**Inquiry and Advisory Committee Report**

**North East Link Project**

**22 October 2019**

Inquiry Report pursuant to section 9(1)

Figure 14 Detail south of Grimshaw Street<sup>115</sup>

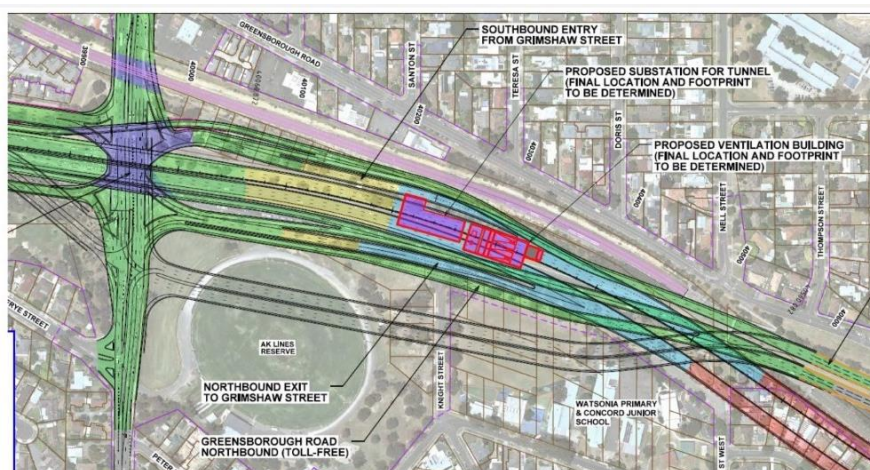
As part of these preliminary investigations, the Proponent had developed a similar option to the BabEng proposal (based on multi-disciplinary team inputs) as shown in Figure 14.

- Necessary to construct a bypass road to maintain Greensborough Road traffic flow resulting in significant acquisition and occupation for several years of large portions of AK Lines Reserve and Watsonia Primary School.
- BabEng proposed a different configuration (Figure 15) which relocates Greensborough Road southbound lanes above and adjacent to the existing railway line. This would add considerable complexity and require further investigations to ascertain its viability (this concept was based on the SMART taxpayer design).
- It is acknowledged that there are considerably fewer surface impacts and this design avoided a range of other adverse impacts compared to trenched scenario.

Figure 33 TBM northern launch site<sup>436</sup>

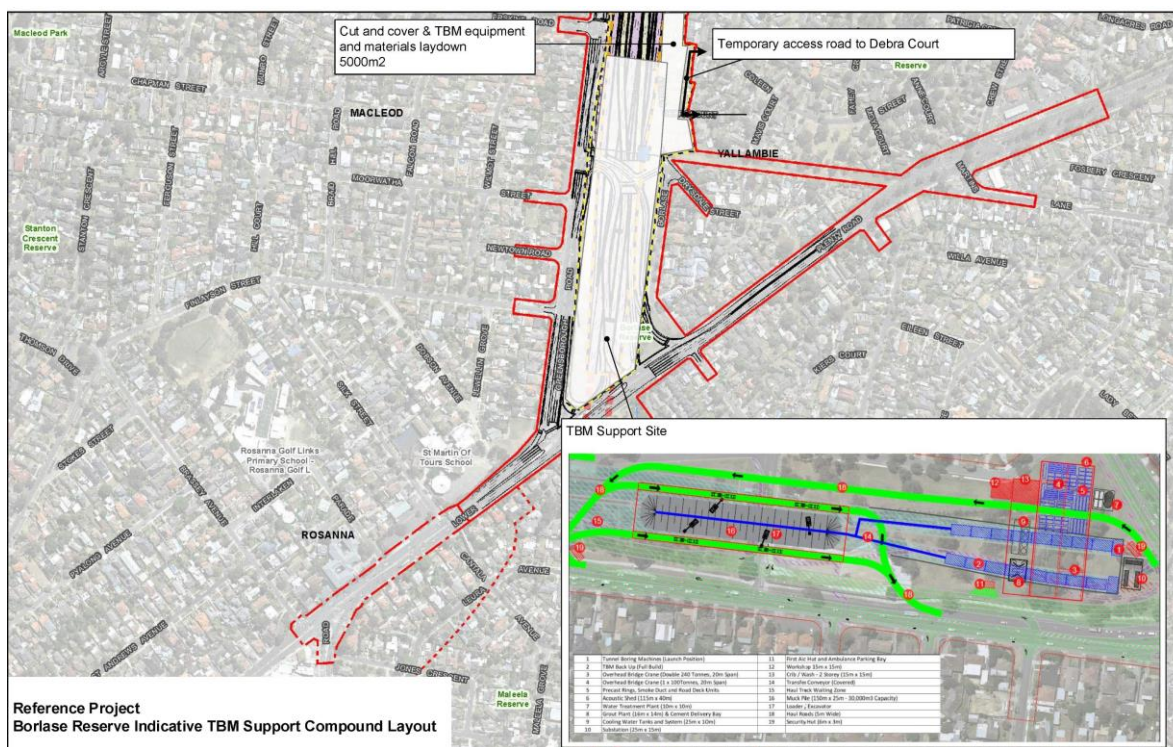
The Proponent has identified Borlase Reserve as a potential TBM support site.<sup>435</sup> If used for this purpose, the IAC does not believe that measures in the EPRs alone will suitably protect residents around Borlase Reserve from high levels of construction noise. The proposed support site would include the TBM launch location, overhead cranes, water treatment plant, grout plant, spoil conveyors and loader/excavator areas for haulage trucks. An indicative layout is shown in Figure 33.

Although it is proposed to construct an acoustic shed around some of the plant, this support site is extremely close to residential dwellings with little to no effective buffer distance. It is clear from the Proponent’s Version 5 EPRs that the works at the TBM site are considered as Unavoidable Works. Residents in the vicinity of Borlase Reserve will potentially be affected by continuous (day and night) noise, for many years.

Figure 34 Aerial photo of Bolin Bolin Billabong<sup>564</sup>

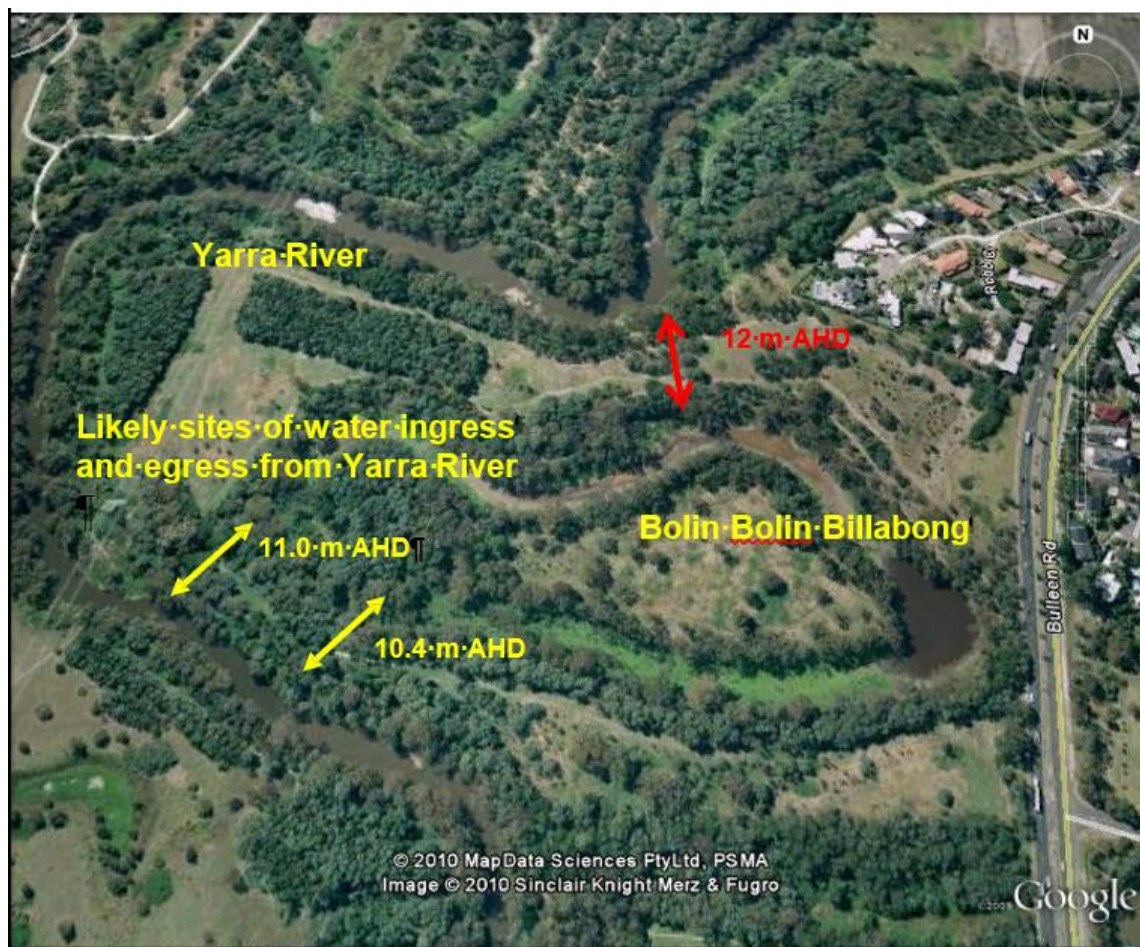
The Bolin Bolin Billabong is an important natural feature adjacent to the Project area as represented in Figure 34. It has been identified in the Map Book as a “conditional no go zone”. It consists of a permanent pool with extensive wet/dry ‘arms’ in a vegetated setting and is one of very few remaining billabongs in the Middle Yarra environs.

The values of the Bolin Bolin Billabong were not fully documented as part of the EES or in expert witness reports although it is understood that this was a significant destination for Aboriginal people used for multiple camp sites, hunting and fishing (including eel and fish harvesting). Technical Note 50 was subsequently prepared on behalf of the Proponent to provide further information from the Historical Place Record on the Victorian Aboriginal
